# The Streets Project

April 15, 2019

Re: *Comments on portions of the Westside Plan - Neighborhood and District Framework, Streets Framework, and Parks and Open Space Framework*

## **2. West Cascade District:**

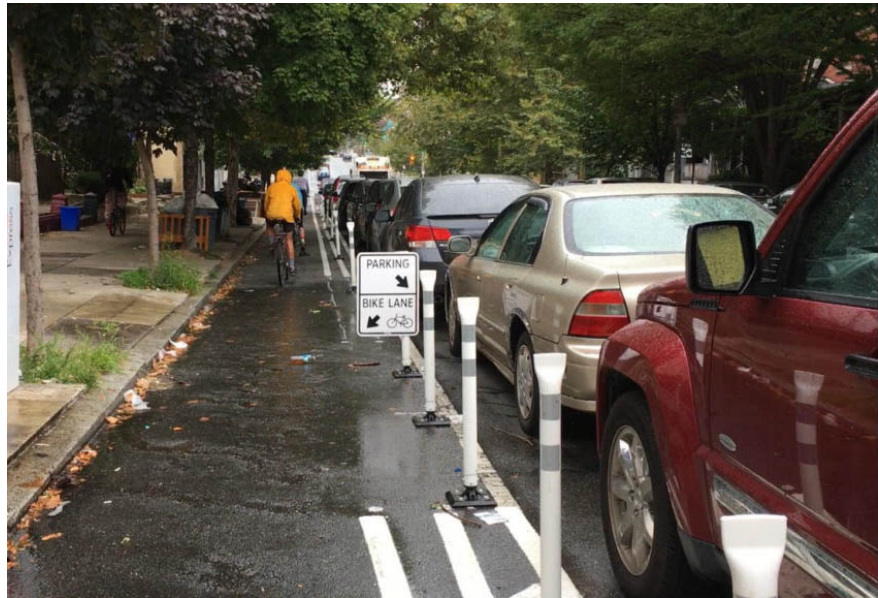
The vision calls for transforming West Cascade's auto-oriented development into a mixed-use district. Land should be used more efficiently (less one-story buildings and more three story buildings containing both commercial and residential uses) and less land should be devoted to parking. The code changes proposed by the Concept Plan Report are good first steps but insufficient to lead to the type of development that is desired. We recommend that the City explore additional code changes (like form-based code and reduced parking requirements) and

also financial incentives such as tax abatement or creating a new Urban Renewal District to help fund a retrofit of the current strip mall-style development. There is a truism in the planning world: get the infrastructure right and the development will follow. If a mixed-use district is desired, Cascade Avenue's public right of way needs to look more like a mixed-use district with street sections that are pleasant and comfortable for people on foot and bike.

*Option 1: Separate walking path and biking path protected from roadway by planting strip*

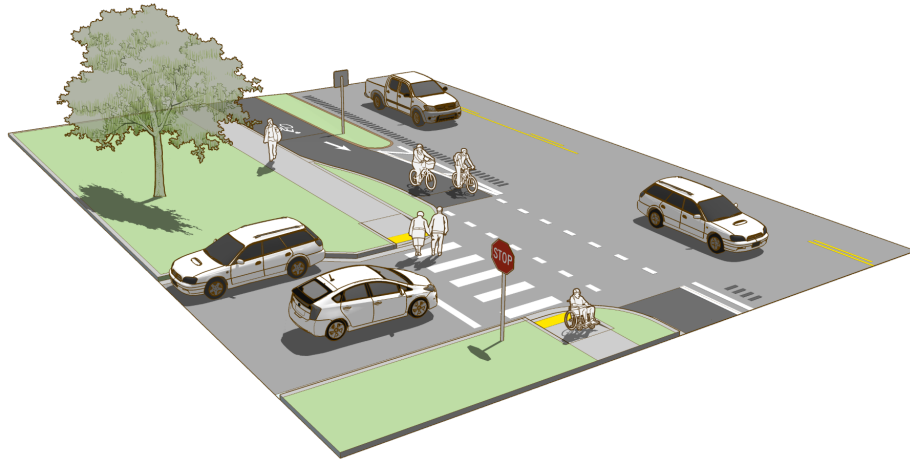
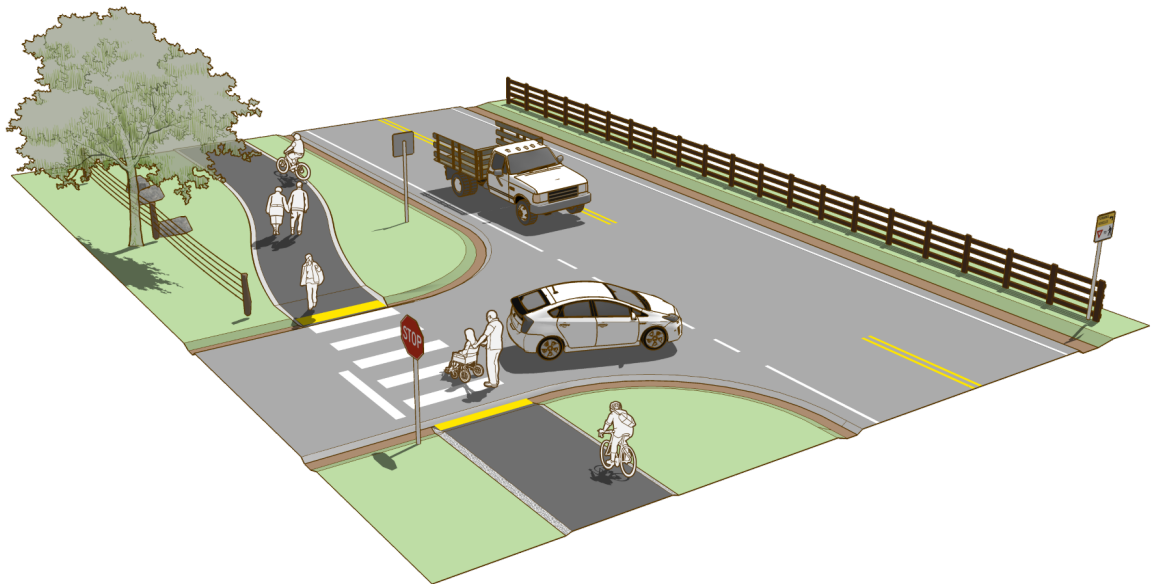
**2. Cascade Avenue** – Transforming West Cascade from strip mall style development to a mixed-use district requires changes in the transportation infrastructure. Currently, Cascade is an uncomfortable street for all but cars: bike lanes are unprotected and pedestrians must use narrow sidewalks connected to the curb. On busy streets, bikes lanes should be physically separated from auto traffic.

We recommend replacing the street section recommended by the Concept Plan Report with one of these two options:

*Option 2: Wide multi-use path separated from roadway by planting strip. 8-80 design and greater comfort for bikes than unprotected bike lanes on road.*

#### 4. Cross Section for 30<sup>th</sup> Street Extension south of May and Belmont/Post Canyon –

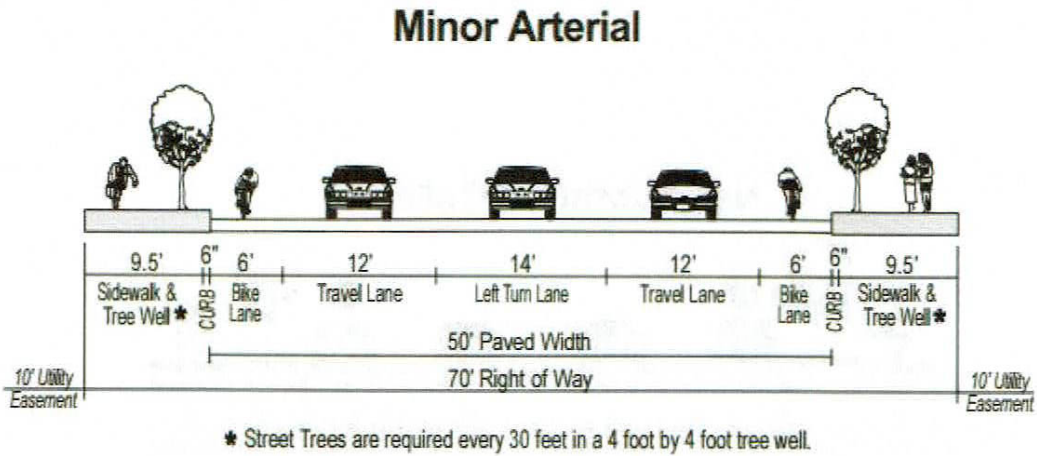
These streets are designated as minor arterials. The approved cross section for minor arterials in the TSP looks like West Cascade Avenue.

**Street Section from current TSP:** too big, takes too much right of way, diminishes every neighborhood it rips through.

Instead, we recommend that Figure 14 Minor Arterial Option Cross-Section for Alignment D is used for the other minor arterials in the Westside area. Again, with the modification that bike lanes are separated and protected from the roadway as shown in Option 1 and Option 2 above.

Figure 14. Minor Arterial Option Cross-Section (Without Turn Lane)

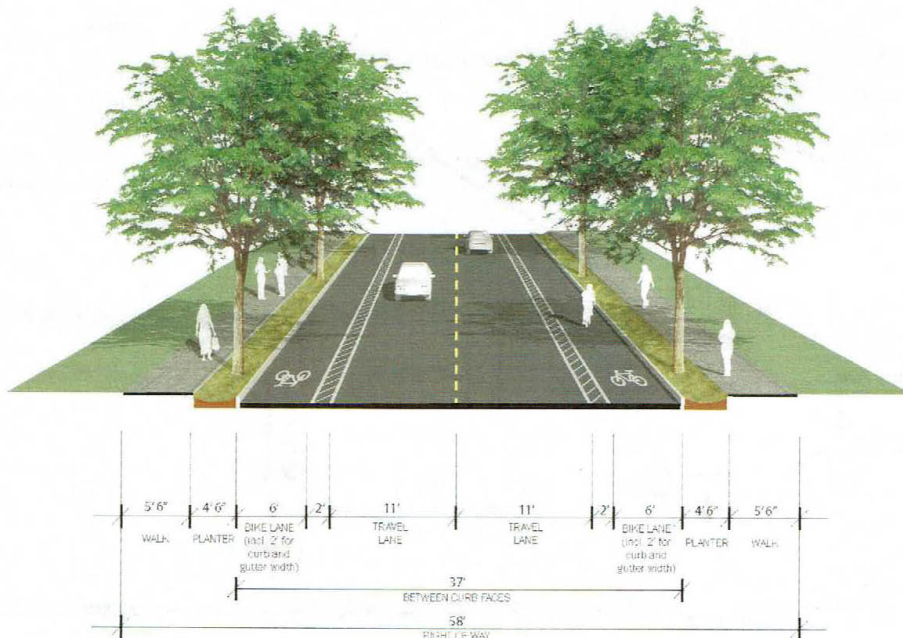
**3. Mt. Adams Extension and Alignment D** – We prefer “Alignment D” to the north-south Mt. Adam/30<sup>th</sup> extension shown in the current TSP. We also support building this arterial as a two-lane street with turn lanes as needed at intersections (Figure 14. Minor Arterial Option Cross Section, page 27 of the Concept Plan Report) rather than using the arterial street section in the TSP which shows a three-lane section (two travel lanes and a central turn lane for its entire length). The Figure 14 Option will allow for needed traffic flow but is more appropriate in the context of this neighborhood. A West Cascade-style three-lane arterial would rend the neighborhood in two. However, we recommend modifying Figure 14 by moving the bike lanes off the roadway as in the street sections Option 1 and Option 2 pictured above.

Figure 19. Bicycle and Pedestrian Connections

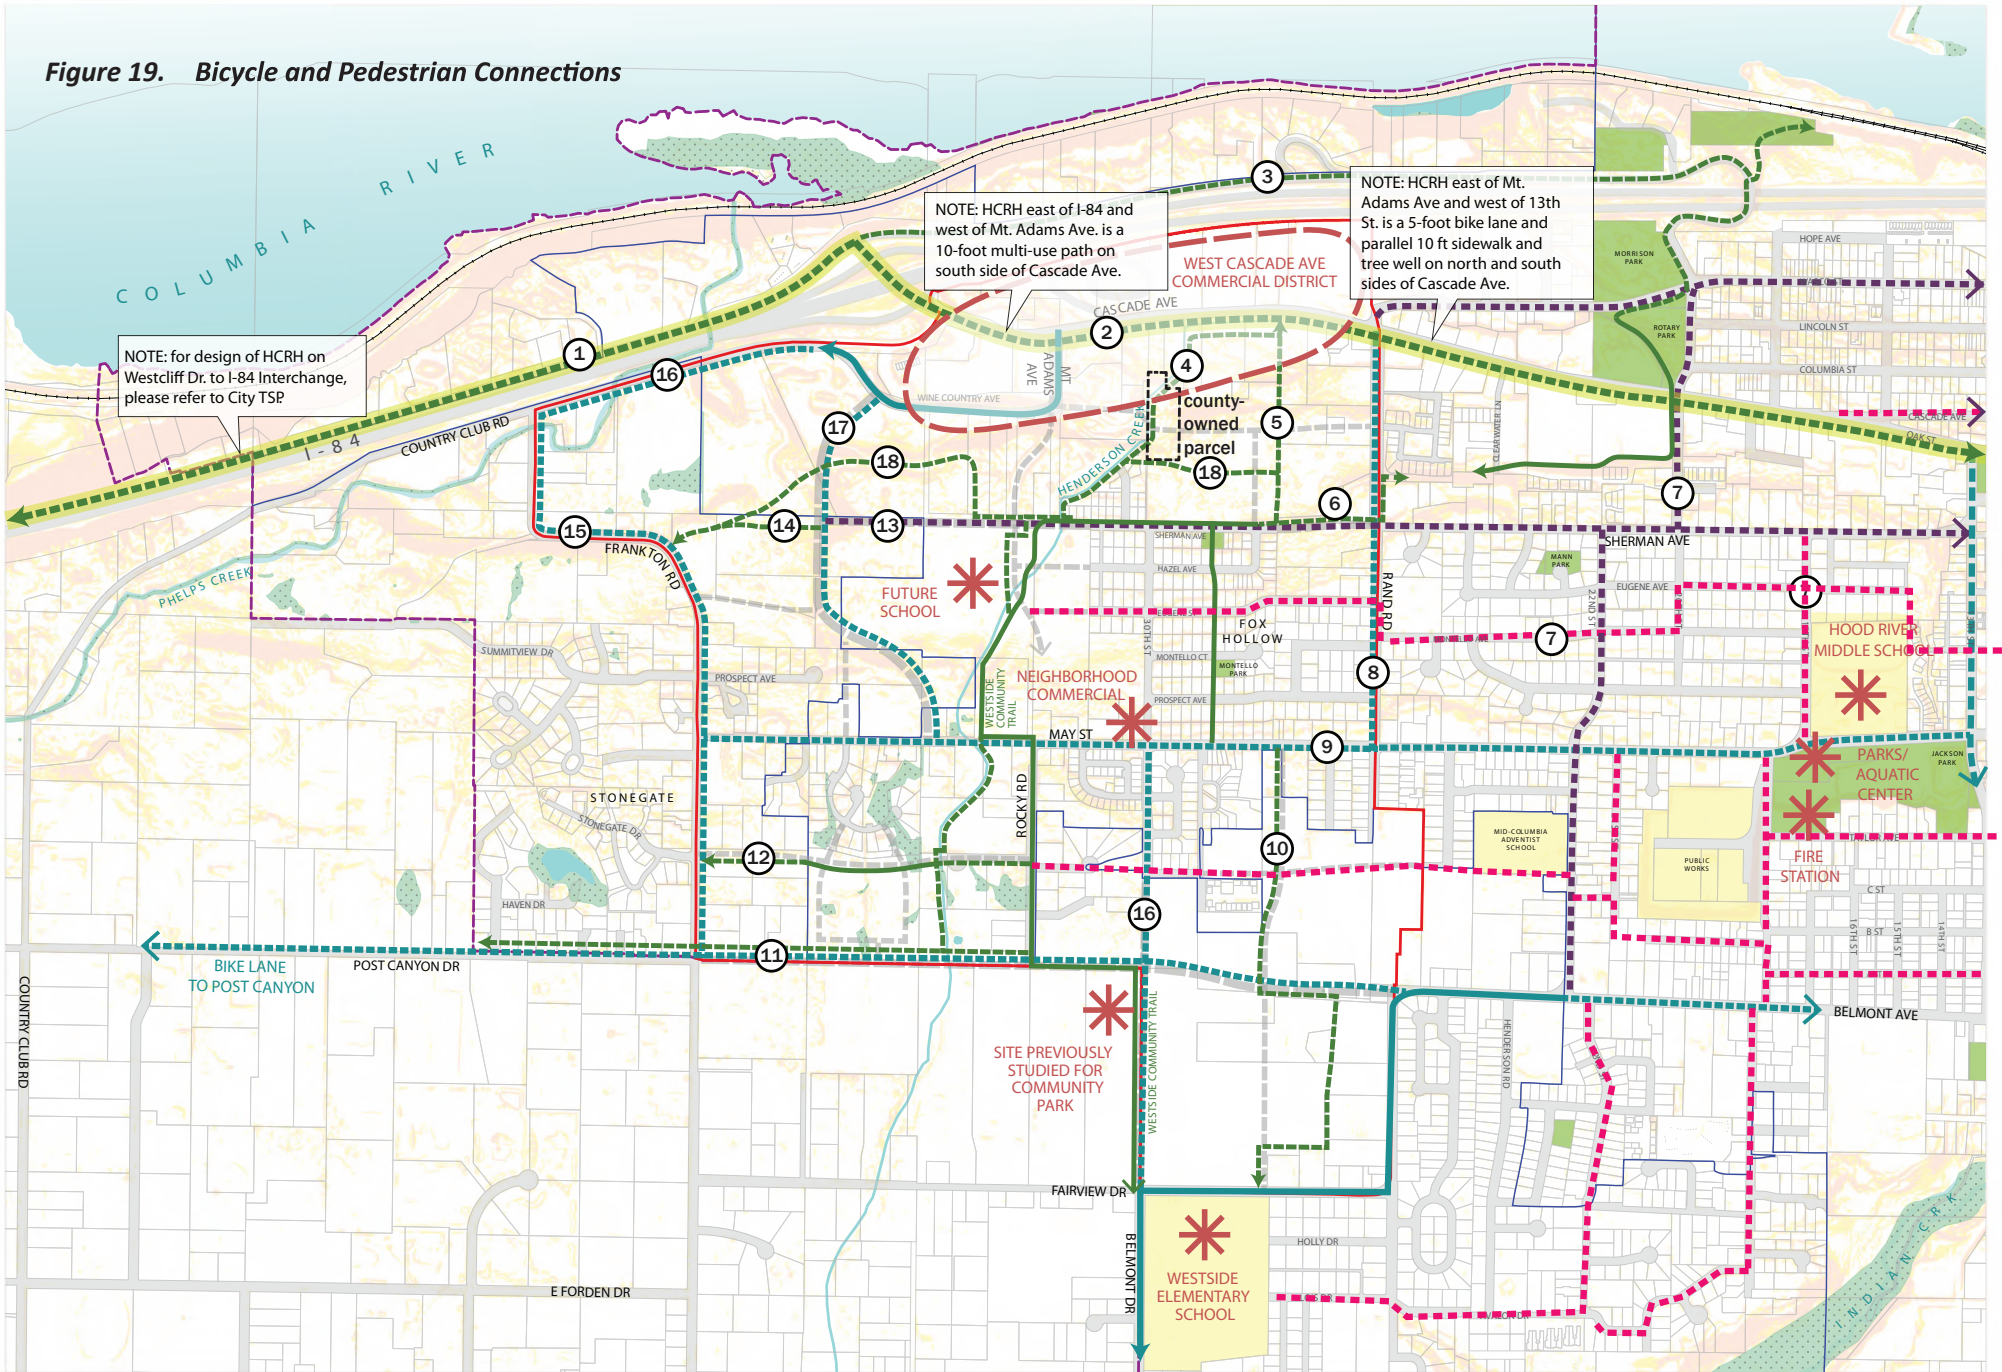
The next page shows a map we made of our preferred Bicycle and Pedestrian network.

**1. Neighborways** – The Concept Plan Report Bicycle and Pedestrian Framework depicts some “Future Sharrows” and the TSP shows a network of “Bike Boulevards”. We suggest instead a network of “Neighborways”. Neighborways are residential streets designed to give priority for people, young and old, to walk, bike and play. Neighborway projects focus on improving residential streets by calming vehicle traffic, making them easier to navigate and friendlier for walking and biking. They will combine street design measures tailored to each neighborhood, including speed humps, traffic circles, crosswalk upgrades and restrictions on thru traffic. If you have driven on residential side streets in Portland you are probably familiar with some of the treatments.

**2. Protected Bike Lanes** – Bike advocates like to say that “Paint is not infrastructure.” Meaning that merely painting a bike lane on a roadway without providing any physical barrier between cars and bikes does little to improve safety or use by cyclists. Most people still feel too vulnerable. If there are bike lanes on arterial or collector streets, they should be protected bike lanes, either by creating a barrier, using parking as the barrier or by moving the bike path off the roadway.

**3. Off road trails**—We enthusiastically support the Westside Community Trail, Henderson Creek trail and the Ridgeline trail as shown in the Concept Plan Report. All of these trails should be included in the TSP as they are transportation facilities. We believe these will be key walking and biking routes for many trips in the Westside. Time is of the essence. Easements for these trails should be obtained as soon as possible. When the consultants devised their plan, the tree cover of Oregon oaks on the ridgeline was one of the proposed trail’s most attractive features. Many of those trees are now gone. We recommend that your Commission consider modifying the City’s code so that it is more protective of natural features.
